April 2021  
FL860AB  
NHTSA #20V-527  
Transport Canada #2020-408  
REVISED NOTICE

## **Subject: Freightliner Engine Harness Clearance**

**Models Affected: Specific Model Year 2018-2021 Freightliner 108SD, 114SD, and Business Class M2 vehicles manufactured May 24, 2017, through August 26, 2020, and equipped with a Detroit Diesel DD8 engine.**

**REVISION:** The torque value on step 2.3 of page 13 of the work instructions has been updated.

**Fig. 13, Current Air Compressor Mounted Bracket Showing Area of Possible Harness Rub**

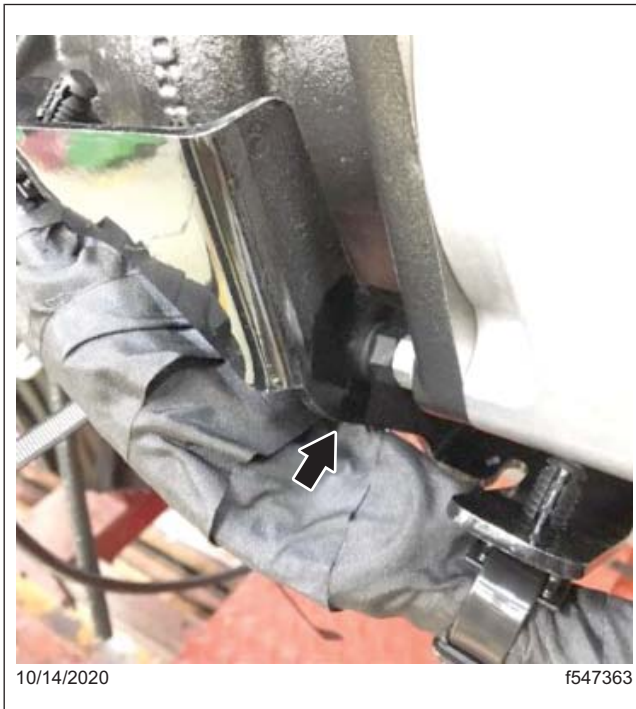
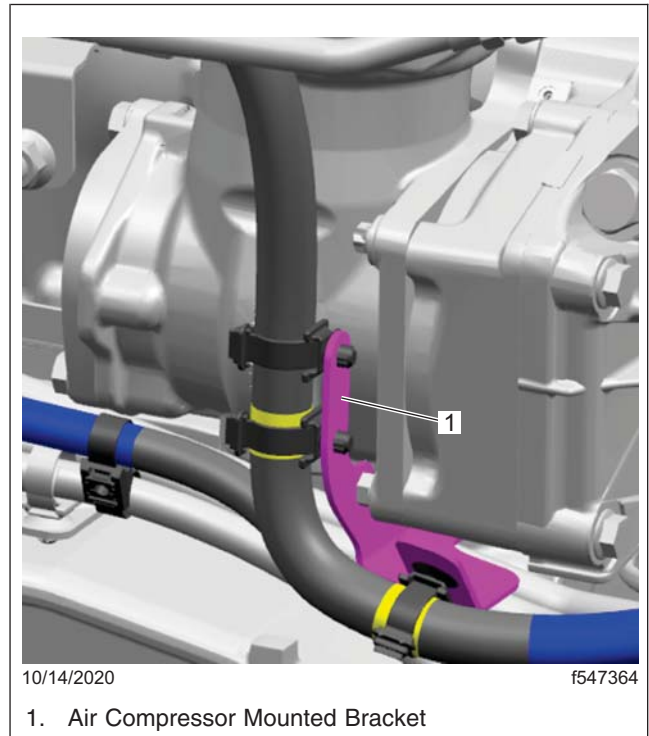
1. Replace the existing air compressor-mounted bracket (see [Fig. 13](#)) with the one supplied in the kit (part number 66-13326-000). See [Fig. 14](#).
  - 1.1 Remove the two fasteners securing the old bracket to the air compressor and remove the bracket.
  - 1.2 Install the new bracket (part number 66-13326-000) then torque the fasteners 27 to 32 lbf-ft (36 to 43 N-m).

**Fig. 16, Existing Standoff Bracket**

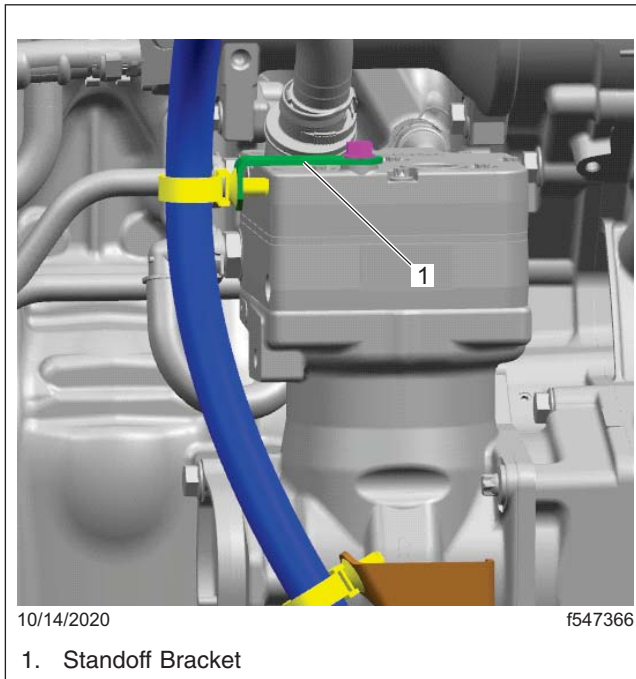
- 1.4 To secure the vertical section of the harness on the new bracket, install fir tree fasteners with tie straps (part number 23-14137-001) in the two holes. See [Fig. 15](#).
2. Remove the existing standoff bracket and install the two new brackets.
  - 2.1 Remove the existing standoff bracket bolted to the top of air compressor. See [Fig. 16](#).
  - 2.2 Install the new brackets onto the top of air compressor where existing standoff was removed. See [Fig. 17](#). Install the parts in the following order:
    - washer (part number 23-09114-011)
    - standoff bracket (part number 23-09130-017)
    - standoff bracket (part number 23-13516-001)
    - M8 bolt (part number 23-13345-025).
  - 2.3 Torque the fastener for the brackets to 11 lbf·ft (15 N·m).

Fig. 19, Population B: Existing Standoff Bracket

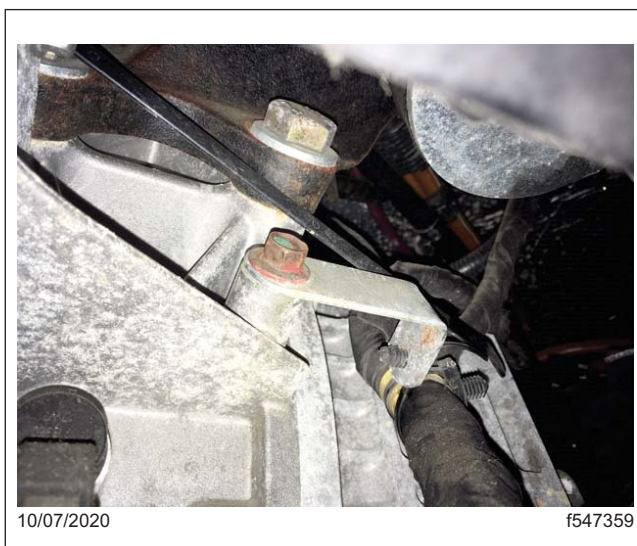
1. Replace the existing standoff bracket (see Fig. 19) at the left side of the flywheel housing with a new stand-off bracket from the kit (part number 23-13514-021). See Fig. 20.
  - 1.1 Install the bracket using the new washer (part number 23-09114-001) and the existing bolt and torque to 27 to 32 lbf·ft (36 to 43 N·m).
